**RESPONSE TO REQUEST FOR ADDITIONAL INFORMATION****APR1400 Design Certification****Korea Electric Power Corporation / Korea Hydro & Nuclear Power Co., LTD****Docket No. 52-046****RAI No.: 264-8243****SRP Section: 06.02.05 – Combustible Gas Control in Containment****Application Section:****Date of RAI Issue: 10/22/2015**

**Question No. 06.02.05-6**

**Figure 1 Schematic Diagram for ECSBS Check Valve**

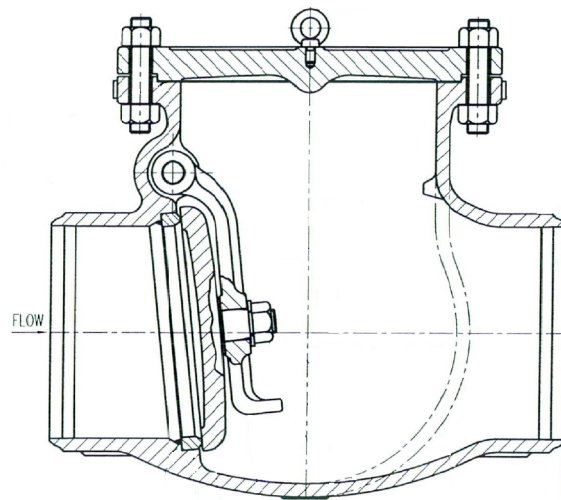
In the equipment survivability analysis described in DCD Tier 2, Section 19.2.3, credit is taken for maintaining the containment pressure below the factored load category of 123 psia, per DCD Tier 2, Section 19.2.4.2.3, by relying on the emergency containment spray backup system (ECSBS). See DCD Tier 2, Figure 19.1-3, Simplified Diagram – Containment Spray System. This is a single train system, with its own dedicated ECSBS spray ring header and an inside containment isolation check valve, V1014. This backup spray function is the basis provided for limiting the equipment survivability analysis to 24 hrs, as stated in DCD Tier 2, Section 19.2.3.3.7.2, "Determination of Severe Accident Environmental Conditions." This valve should

be shown to meet the equipment survivability conditions, including surviving a hydrogen burn and remaining open. This valve should be added to DCD Tier 2, Table 19.2.3-4.

The check valve has another function of water delivery to the ECSBS header during severe accidents. However, the ES evaluation of the check valve is the same as piping due to its water delivery function to the ECSBS header, for the following reasons:

- The check valve resists damage due to temperature increases because the check valve consists of only metallic parts; the valve contains no organic materials. The metallic parts resist thermal damage which result from the hydrogen burn or the continuous temperature rise which results from decay heat.
- It is expected that the check valve continues to function due to its simple structure, as shown in Figure 1.

Therefore, it is not necessary to additionally evaluate the survivability of check valve V1014, and it is not required to be added to Table 19.2.3-4.

Figure 19.1-3 Simplified Diagram - Containment Spray System

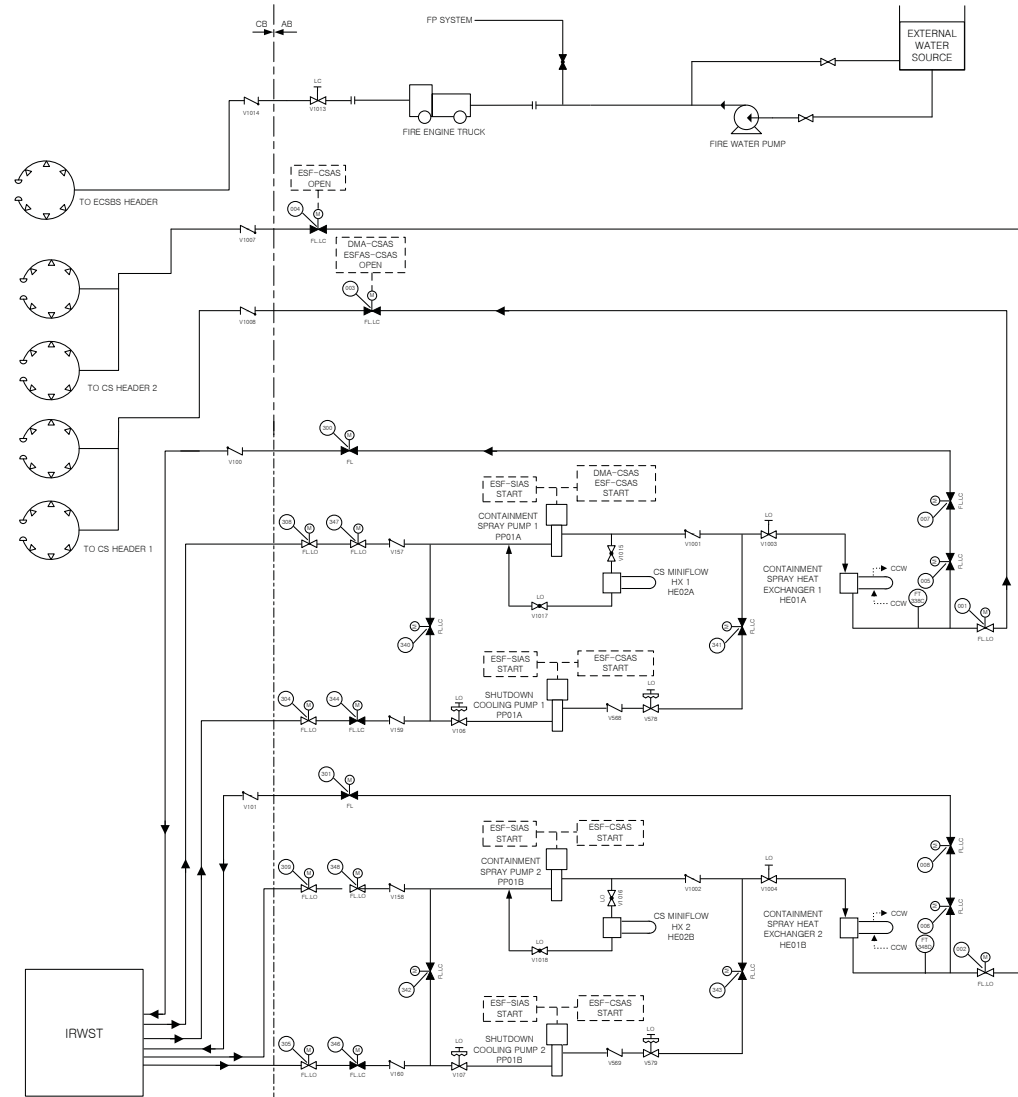
Please confirm that all of the check valves shown in DCD Figure 19.1-3, Simplified Diagram – Containment Spray System, are depicted correctly to indicate the direction of flow. Check valves V1014, V1008, and V1007 appear to be shown in an inconsistent direction as compared to V101 and V100. Adding flow direction arrows below the check valve symbol, as done in DCD Tier 2, Table 6.2.4-1, would provide clarification.

DCD Tier 2, Figure 19.1-3 will be revised to correct the directions of flow for check valves (V100, V101, V1007, V1008 and V1014), as shown in Attachment 2 to this response.
